Submissions Report

WELLINGTON NORTH SOLAR PLANT

MARCH 2019

Project Number: 17-382

Figure 3-1 Updated Proposal location.

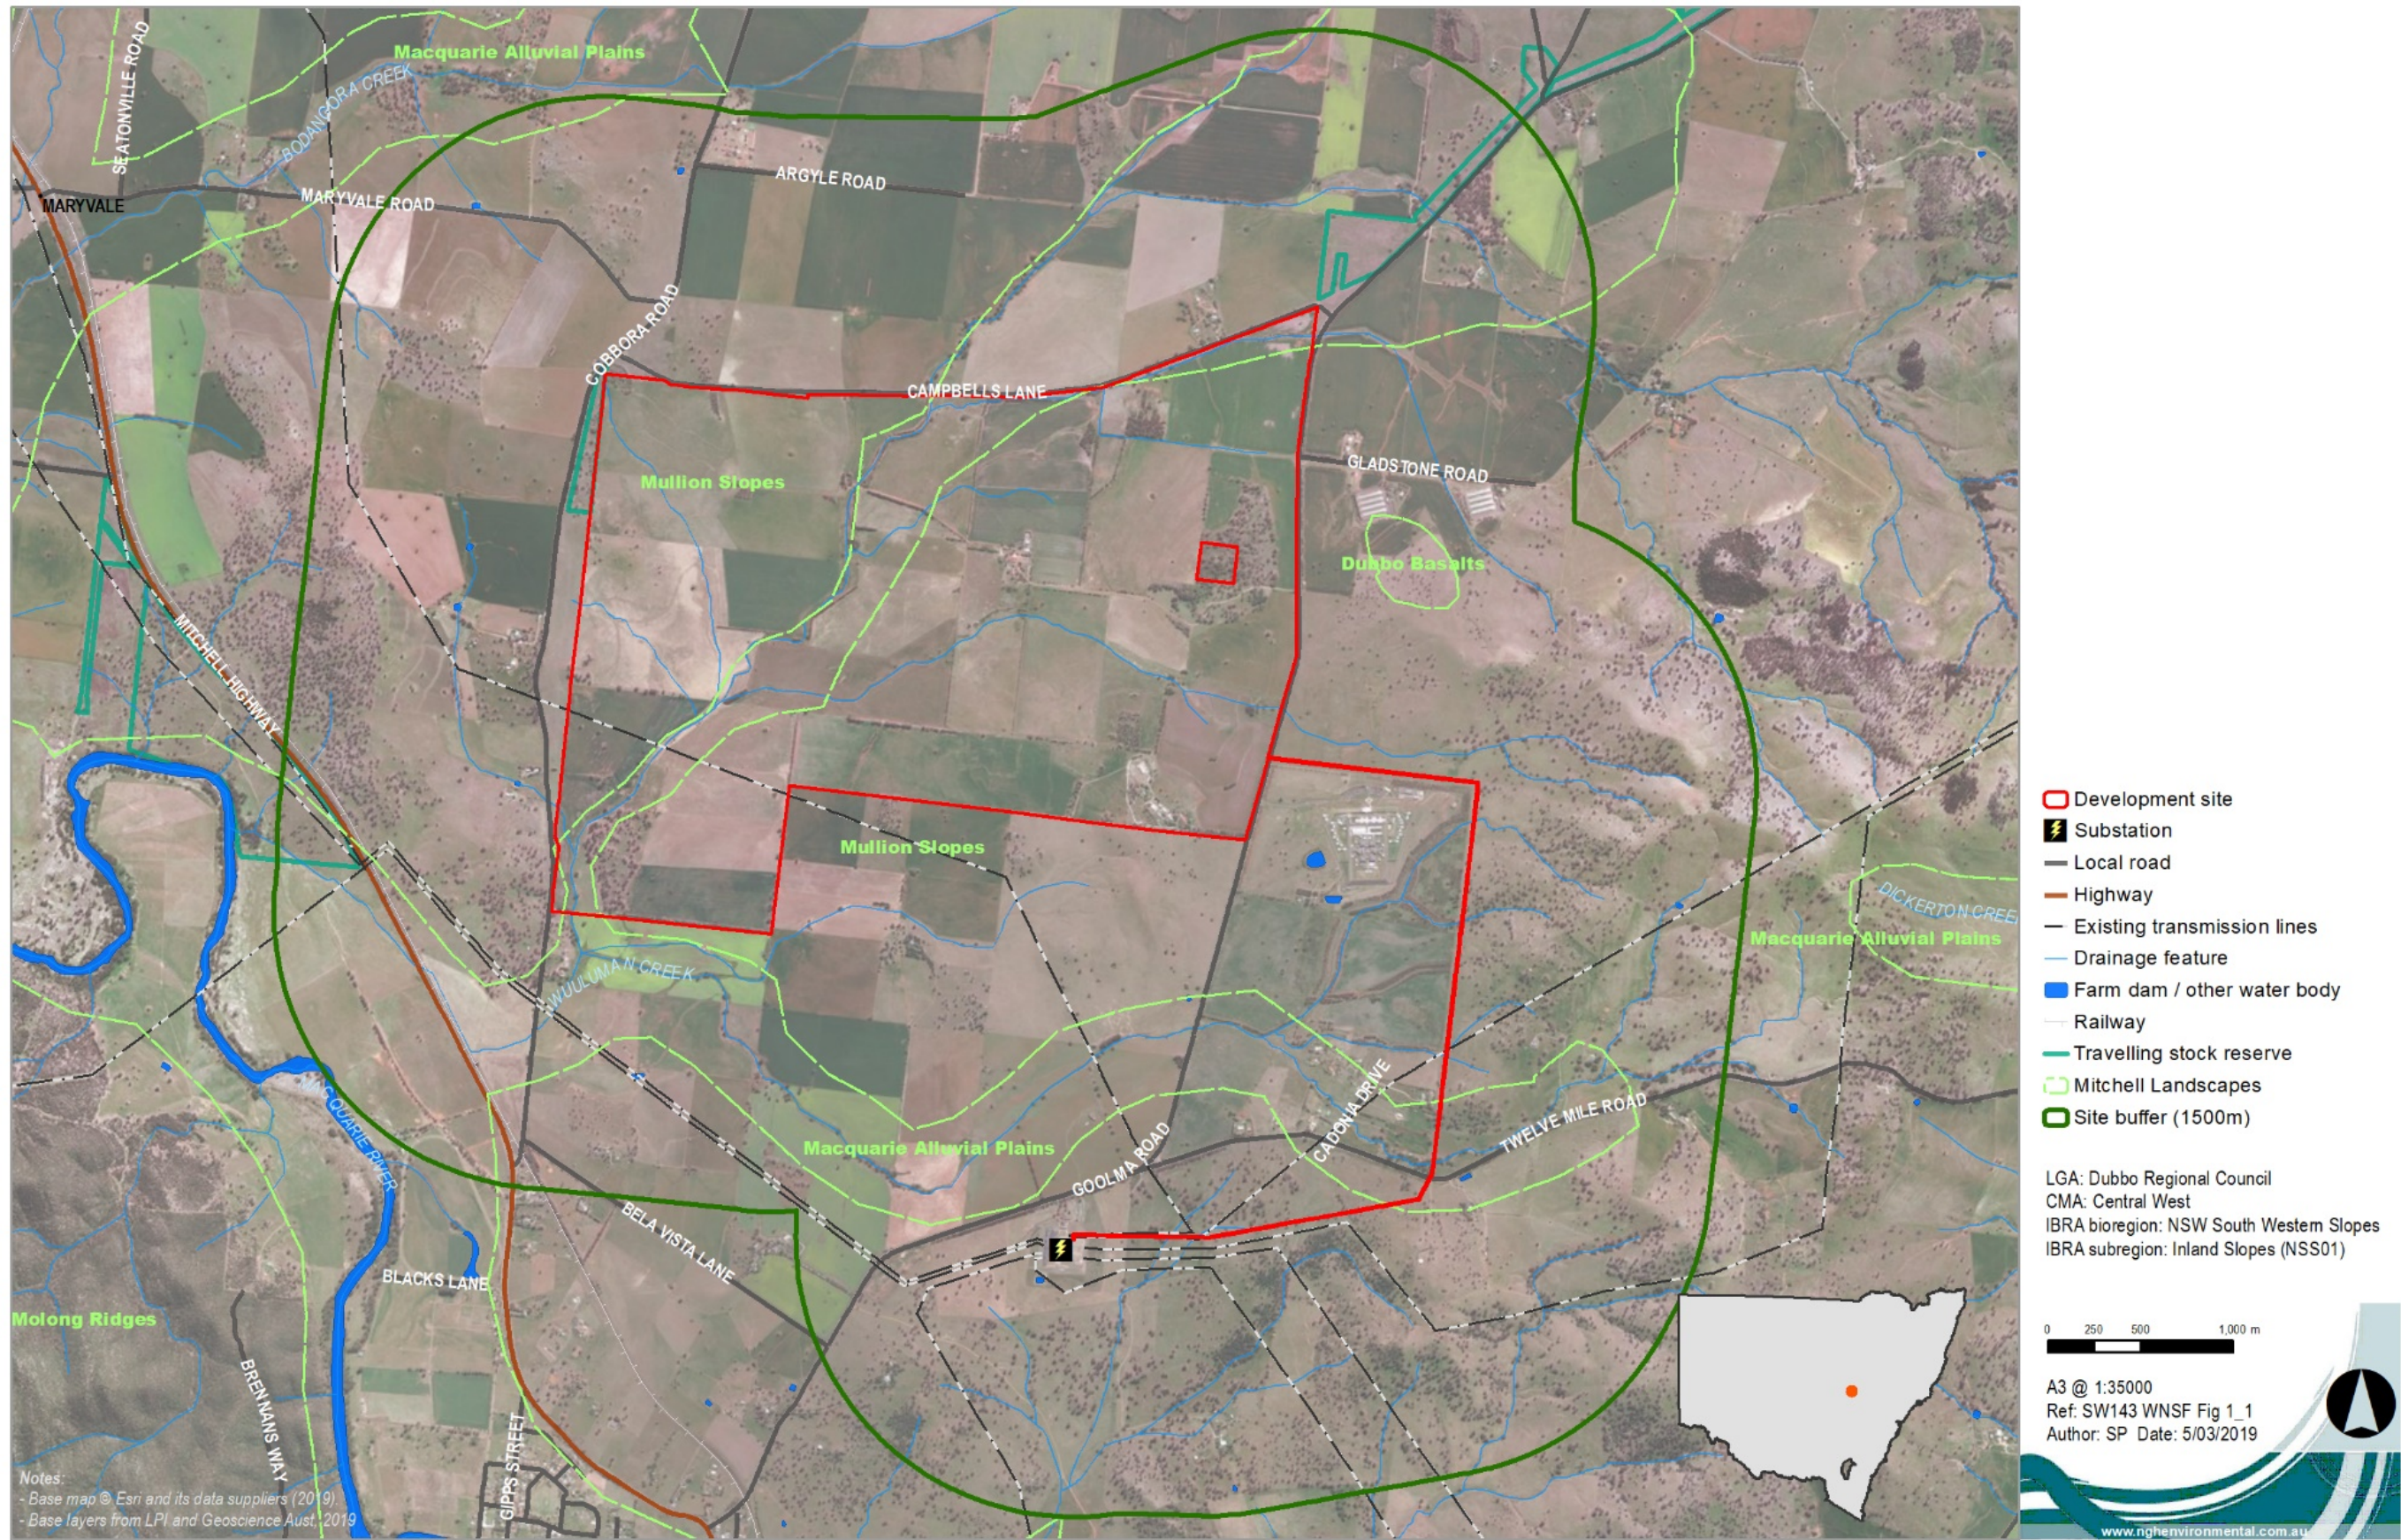
In summary, two changes have been made since the exhibition of the Wellington North Solar Plant EIS. These changes were made in response to submissions (contained within this document) and through further detailed design. The changes relate to the transmission line and access options and are addressed in Section 3 of this report as well as within the Amendment Report (NGH Environmental, 2019).

These changes can be seen in the updated proposal layout and constraints map provided in Figure 3-1 and Figure 3-2.

Figure 3-2 Updated constraints mapping reflecting the proposal changes, showing the approved Wellington Solar Farm (First Solar) to the south of the site.

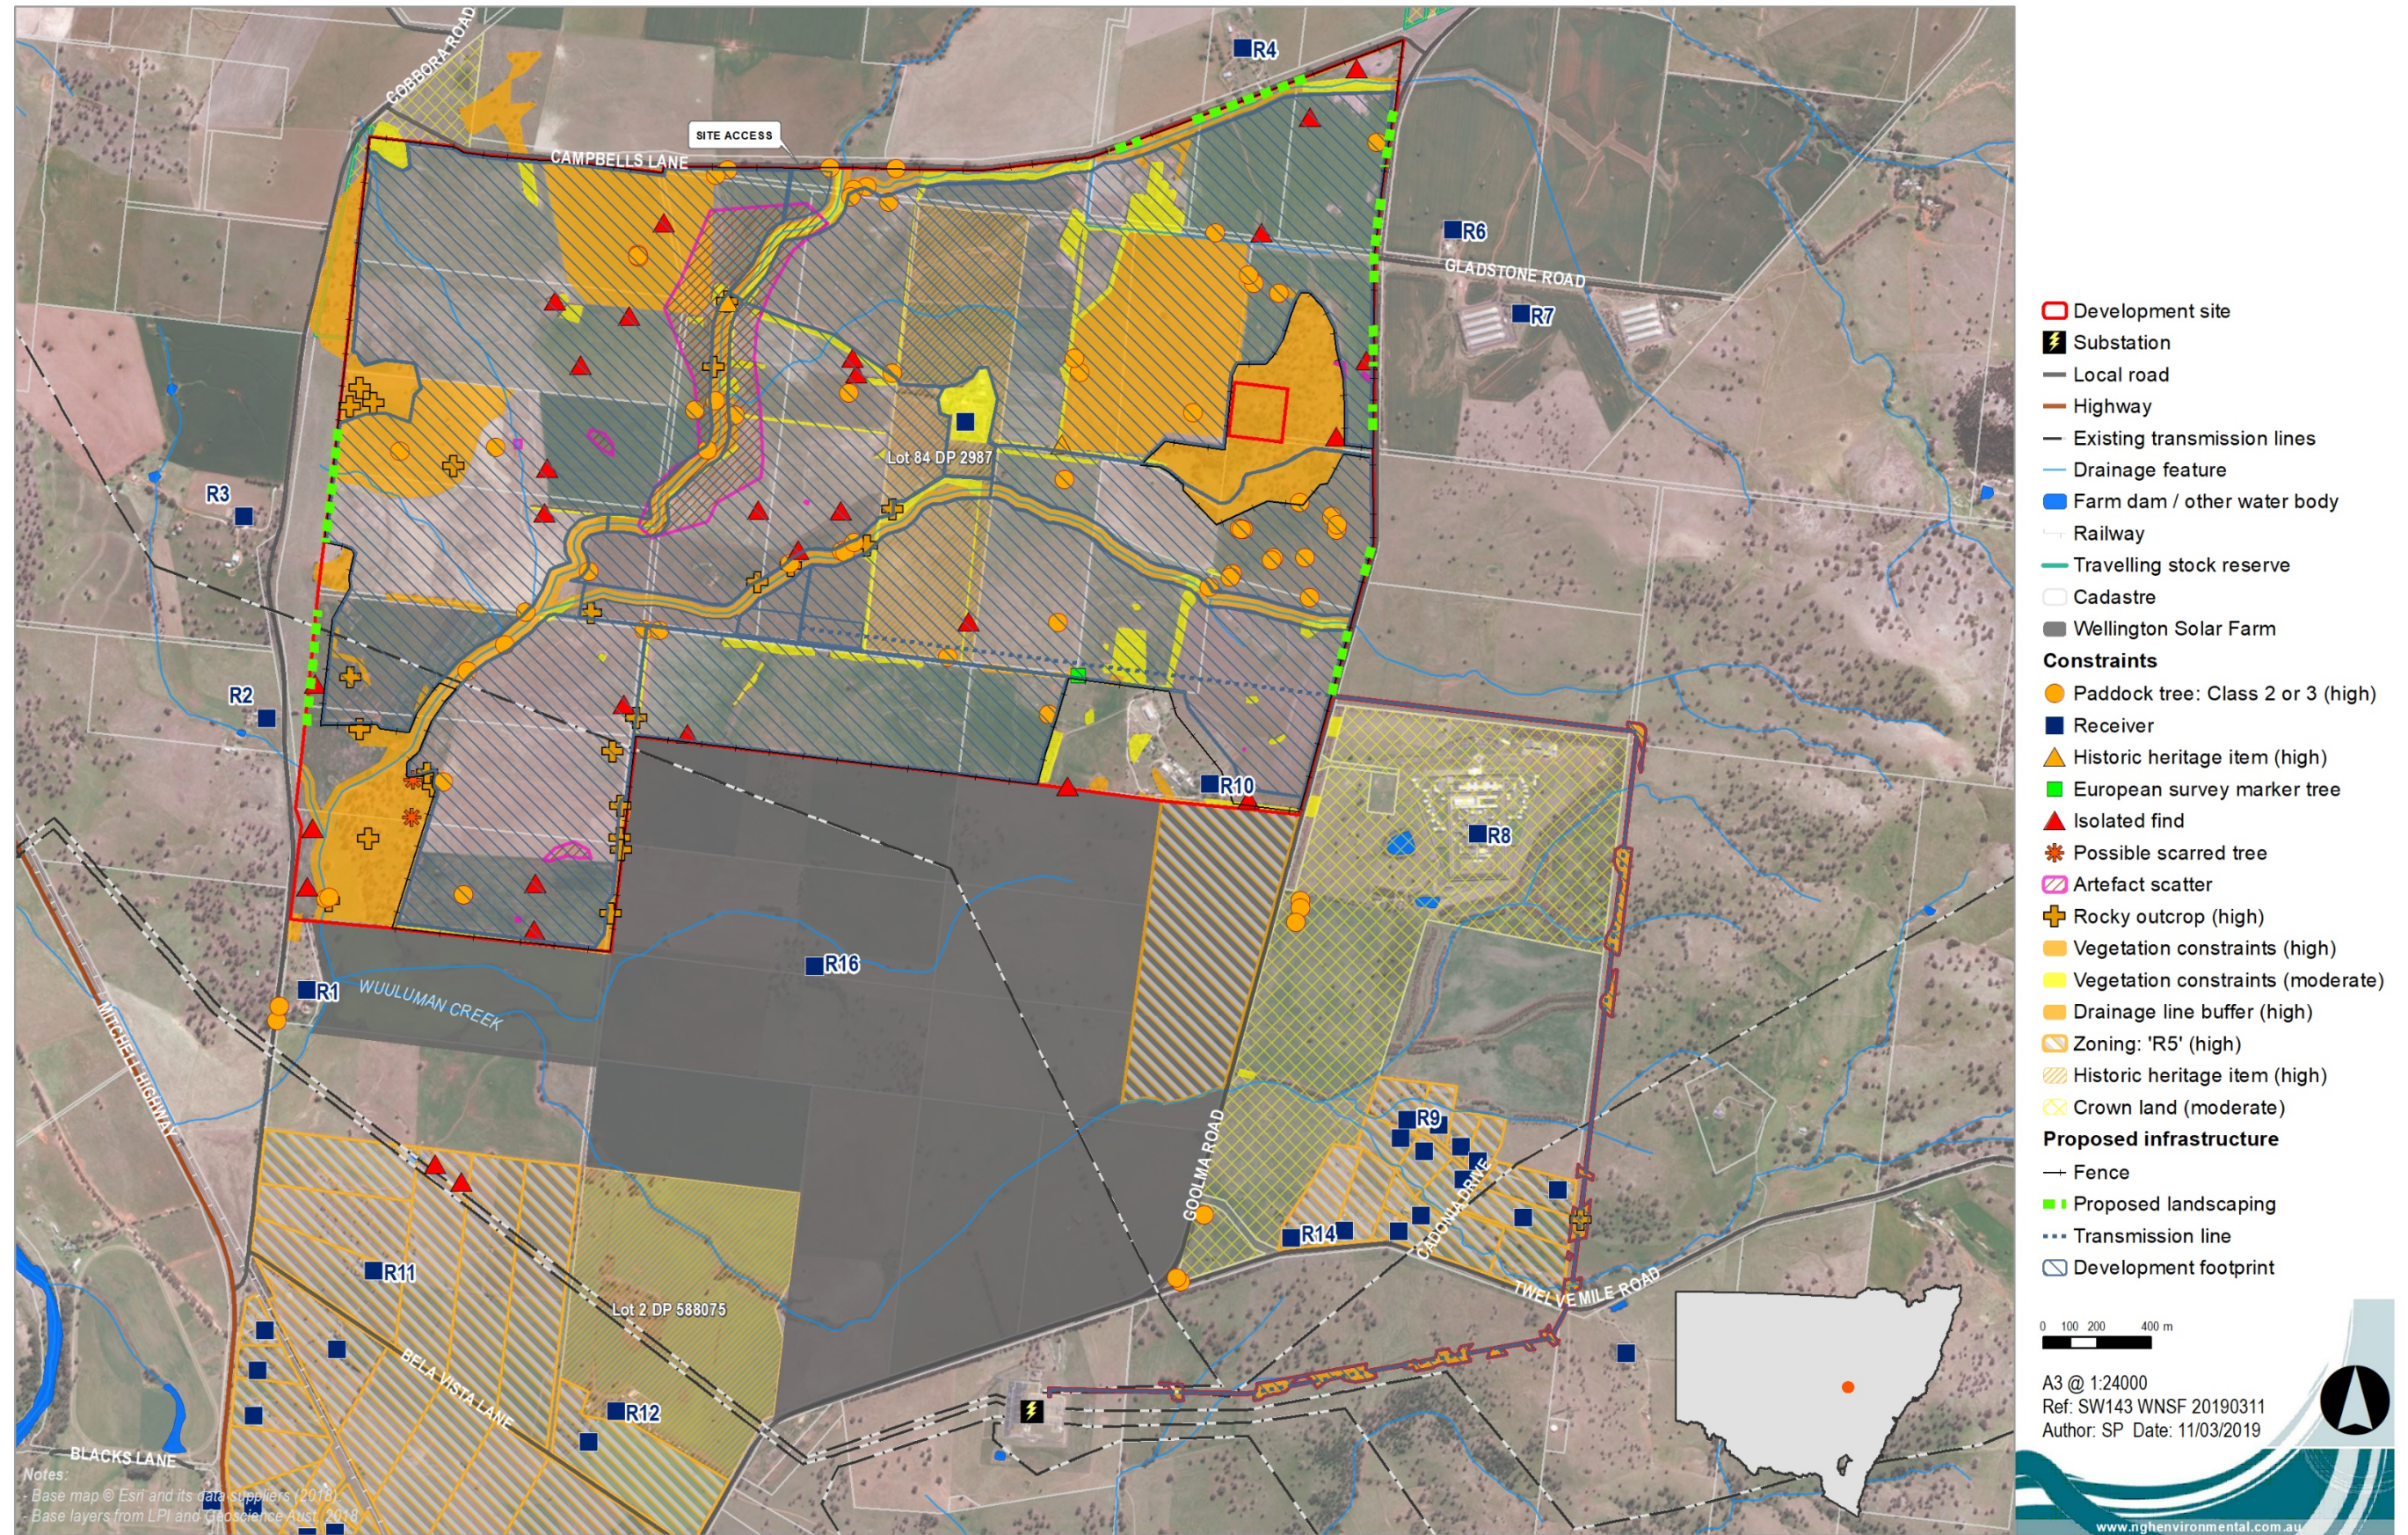
| Issue | Detail of issue | Proponent response |
|----------------------|--|---|
| Landscaping | <p>In order to offset any visual concerns, the implementation of a landscape buffer around the entire perimeter of the development is requested where there is no existing visual buffer through existing landscaping or topographical features.</p> | <p>Based on the VIA, AGL are committed to the following landscaping:</p> <ul style="list-style-type: none"> An intermittent band of screen planting would be located: <ul style="list-style-type: none"> Between the property boundary and the solar arrays, in locations along Goolma Road and Cobbora Road where there is no existing vegetation and where the arrays are immediately adjacent to the boundary. Along the Campbells Lane boundary to mitigate impacts on properties on the northern side of Campbells Lane. |

| Issue | Detail of issue | Proponent response |
|---------------------------|--|---|
| | | <p>The location of the proposed screen planting can be seen in Figure 3-2 and has been developed specifically to augment existing vegetation screening at specific viewpoints. The additional planting requested, rather than softening the impact of views of infrastructure, is considered likely to create an unnatural hedge effect, not in keeping with the existing vegetation formations. Blocking views entirely of the solar farm is not proposed and not considered warranted.</p> <p>No changes to the proposal or mitigation measures are proposed in response to this issue.</p> |
